CITY COUNCIL AGENDA REPORT

**SUBJECT: ZA-05-77 MASTER PLAN AMENDMENT FOR PACIFIC MEDICAL PLAZA
1640 NEWPORT BOULEVARD**

DATE: JANUARY 3, 2006

ORIGINAL ORANGE ELEVATION
 EXHIBIT 1
 ZA-05-077

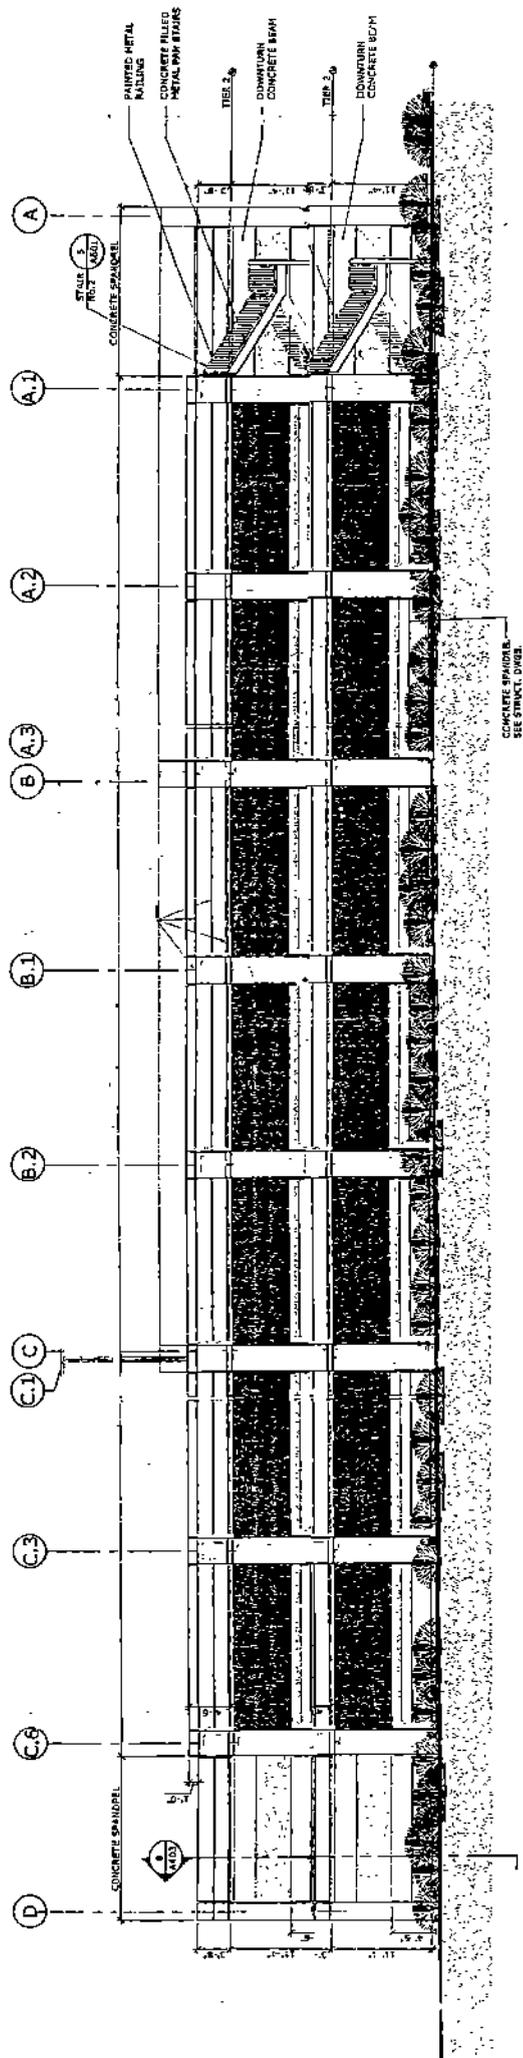
- The parking structure height originally approved for the Orange Avenue elevation was three levels; the current approval is two levels (see Exhibits 1 and 2).
- Exhibit 3 illustrates the landscaping that is proposed to screen the parking structure. The primary screening element is Long-leafed Yellow-wood (Podocarpus henkelii) trees, which are slow growing. Therefore, upon the structure’s initial construction and until such time the trees mature, it would be readily visible to the residential neighborhood, east of Orange Avenue. Staff

Original plan as approved In City Council's, resolution No. 04-64 30 ft. height
 (note need for light spillage control)

EXHIBIT 3 LANDSCAPE PLAN

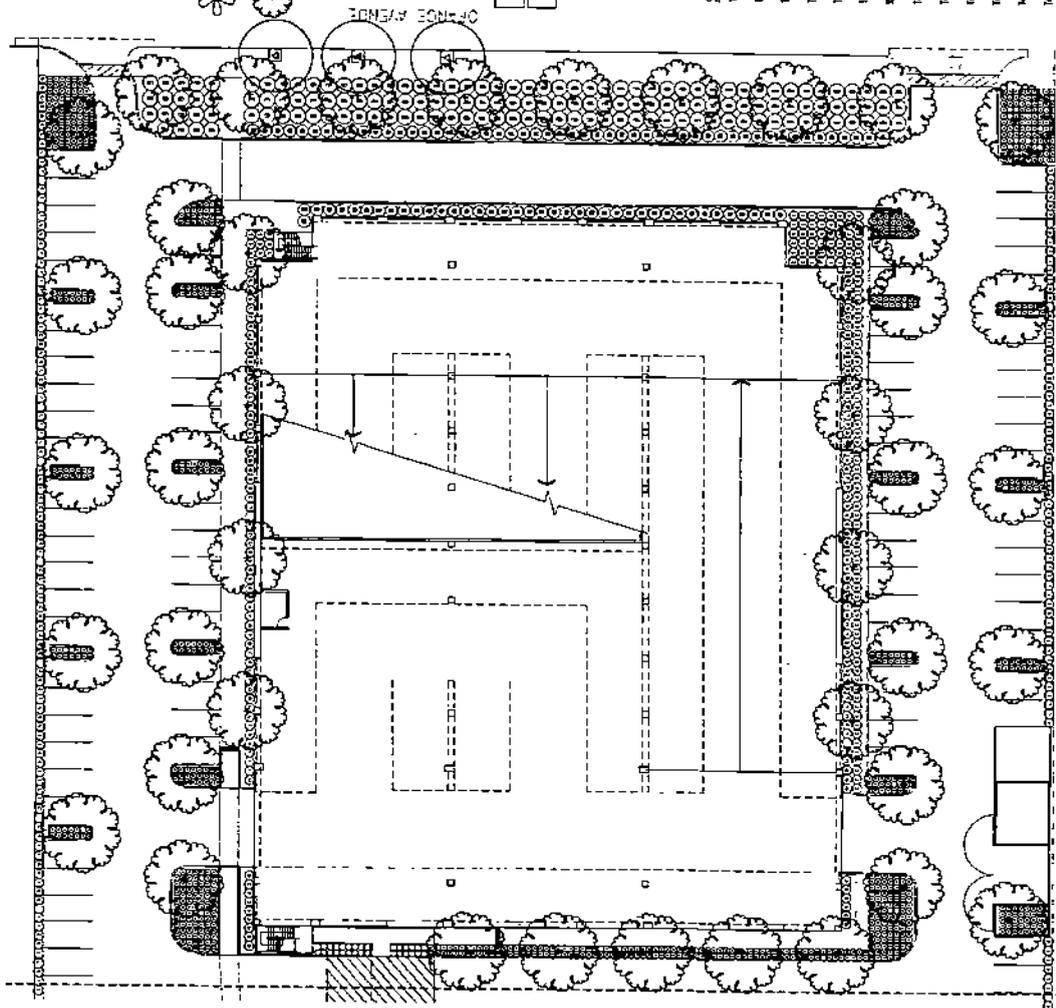
notes that the trees are spaced closely together, and this will quicken the time to effectively screen the parking structure.

Also, as presented later in this application, we are proposing a revised and enhanced landscaping plan to address the issue of light impacts on adjacent properties. If approved, that landscaping plan will mask the building to such a degree that enhanced architectural details will be virtually hidden from Orange Avenue. We therefore request relief from the architectural enhancements referenced in this condition.

EXHIBIT 4

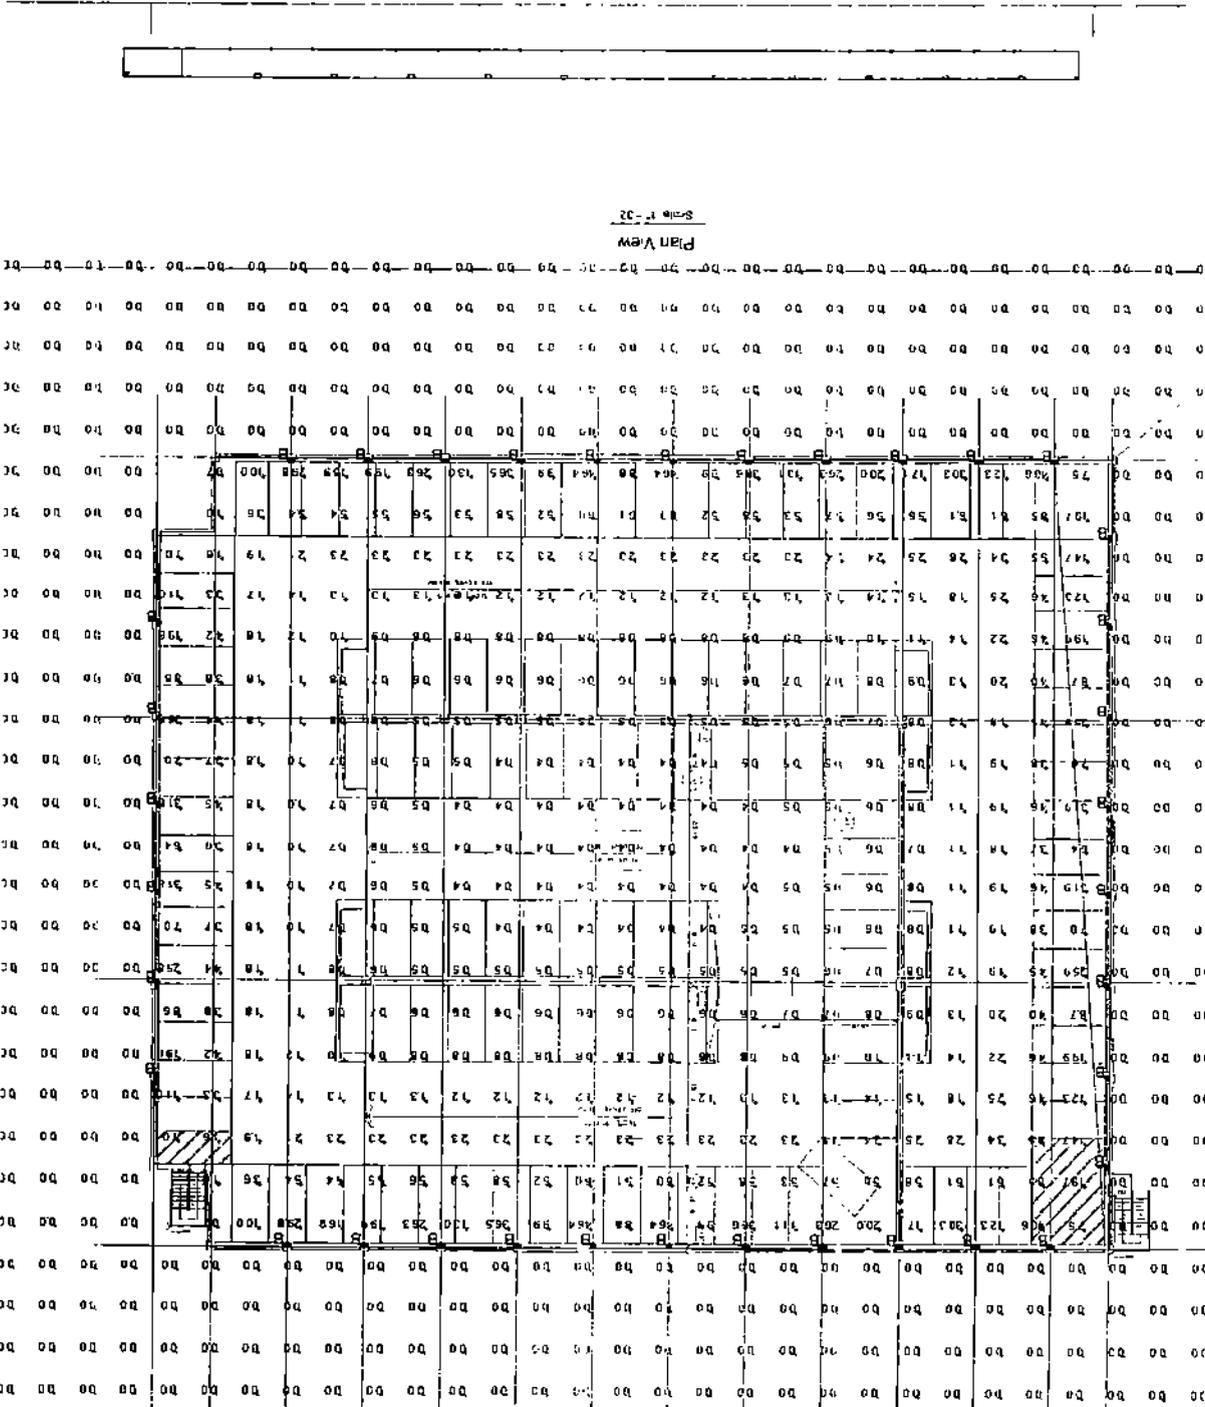
- The parking structure's height has been reduced by one-half; the new design has no top level but only an angled driveway.
- An alternative lighting plan is proposed using standard light fixtures that adequately lights the parking structure with no light spillage. The EIR mitigation measure that restricts the light standards to not extend above the parapet wall of the top level results in lighting that falls short of the coverage and illumination minimums required by code (minimum 1 foot-candle)(Exhibit 4).

The lighting plan proposed by staff has been thoroughly tested by our lighting consultants numerous times and the proposed use of wall-mounted lights falls far short of the coverage and illumination minimums required by code.

The proposed alternative plan, using standard light fixtures, not only fulfills the code requirements but allows virtually no light spillage beyond the parking structure itself. The top of the light standards themselves will be visible from street level, but that represents a very minor visual impact for a number of reasons.

The overall intent of these mitigation measures is to keep light levels to an absolute minimum at the rear of the project site in order to minimize impacts to the adjacent residential neighborhood. Although the proposed lighting plan results in an acceptable level of lighting adjacent to Orange Avenue (0.5 foot candles or less), the necessary night-time security lighting on and around the parking structure will make it visible in the evening. Staff also believes that a combination of lighting along the 6 ft. 6 inch high parapet walls and strategic placement of a limited number of light standards in areas where the light level is deficient would result in fewer light standards on the top level.

If Council wishes to allow light standards that exceed the height of the parking structure parapet wall, staff suggests that additional conditions of approval be applied requiring the light standards to be painted a color that blends with the background, reducing the height of the standards to a maximum of 12 feet, and requiring all the light standard fixtures to be directed away from Orange Avenue

and appropriately wired so that each standard may have its illumination reduced to 50% or less.

CROSS SECTION
EXHIBIT 5

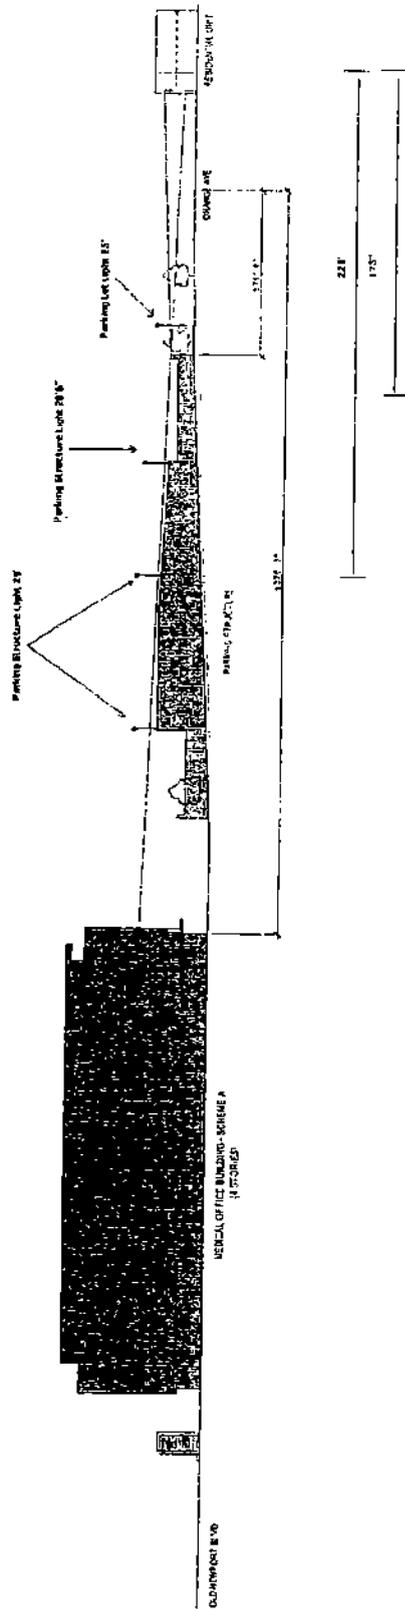
- As shown in Exhibit 5, only the top of the light standards will be visible from Orange Avenue.
- Of the apartment buildings that face the parking structure, only 4 units have windows that face the parking structure. As shown in Exhibit 5, the first light standard on the structure is 150 feet from the apartment buildings and due to the site's significant change in grade away from Orange Avenue; the light fixtures on the upper level will appear to be only slightly higher than the light standards in the surface parking lot.

One, the only adjacent residential is the apartments along Orange, which actually face Ogle, not Orange, with the exception of one unit. Of all the apartments, only four units have windows that face the project site at all. Two, the parking structure will be both heavily landscaped and set back well away from Orange, with the first light standard on the structure some 150 feet from the apartments across the street. Three, and perhaps most important, due to the site's significant change in grade away from Orange Avenue, the light fixtures on the upper level of the parking structure will appear to be just slightly higher than the light fixtures in the surface parking lot.

In respect to the height of the parapet wall, staff supports retention of the minimum height of 6 feet 6 inches on the top level. As shown in Exhibit 2, the applicant is proposing that the top-level concrete spandrel be a total height of 4 feet 6 inches. The addition of two feet to the parapet wall will allow the placement of lighting inside the wall's perimeter and provide further shielding of headlights and security lighting on the parking structure's top level.
